# Work Session Memorandum

To: Salt Lake City Historic Landmark Commission  
From: Carl Leith, Senior Planner  
801 535 7758 or [carl.leith@slcgov.com](mailto:carl.leith@slcgov.com)  
Date: July 19, 2018  
Re: **PLNHLC2018-00454 Rehabilitation of Cottage and New Additions at approximately 287 G Street and 480 6<sup>th</sup> Avenue**

## REHABILITATION OF COTTAGE & NEW ADDITIONS

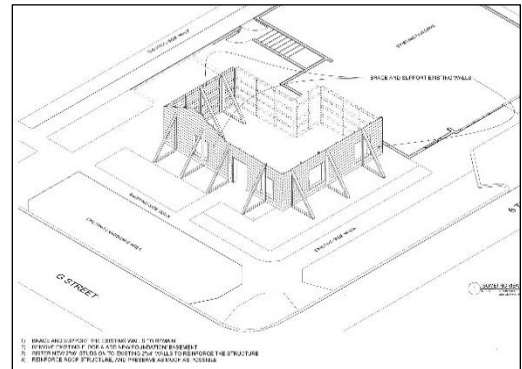
The applicant currently proposes to ‘rehabilitate’ the current historic cottage, constructing a new foundation and basement, removing three sections of rear wall and linking the building with a new addition adjacent to the east of the commercial building at 480 6<sup>th</sup> Avenue. This proposed additions would extend the interior area of the building, occupy the gap between the two buildings along the west side of the cottage, replace the existing garage structure and extend this towards G Street approximately half way along the original south wall of the cottage. Proposals would also remove the interior walls of the cottage. Identified future use of the building is currently proposed as ‘retail’. Two alternative options are presented in this application, each defined in a series of phases.

- **Proposal 1** would retain the north, east and south walls and the roof of the cottage, brace and reinforce the current structure, demolish sections of rear wall adjacent to 480 6<sup>th</sup> Avenue, demolish the garage structure to the south-west of the cottage, and construct a new addition extending eastward in place of the current garage structure along and enclosing part of the south facade of the cottage. Interior cottage walls would also be demolished.

The proposed phases of construction can be summarized as:  
Proposal #2

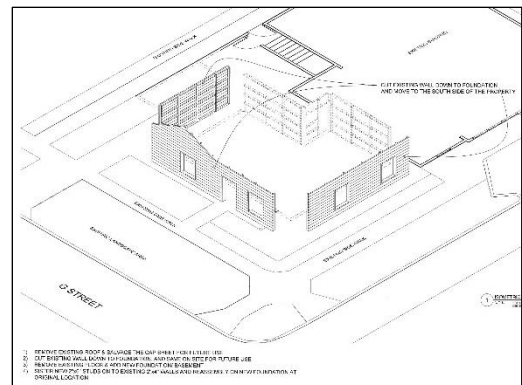
- **Proposal 2** would include the same areas of demolition, with again the construction of a new foundation and basement and the construction of the additions. Alternatively, however, it would remove the roof of the cottage, cut the existing walls of the building at foundation level and move these aside to carry out the basement and foundation work, reassembling the walls at a subsequent phase of construction.
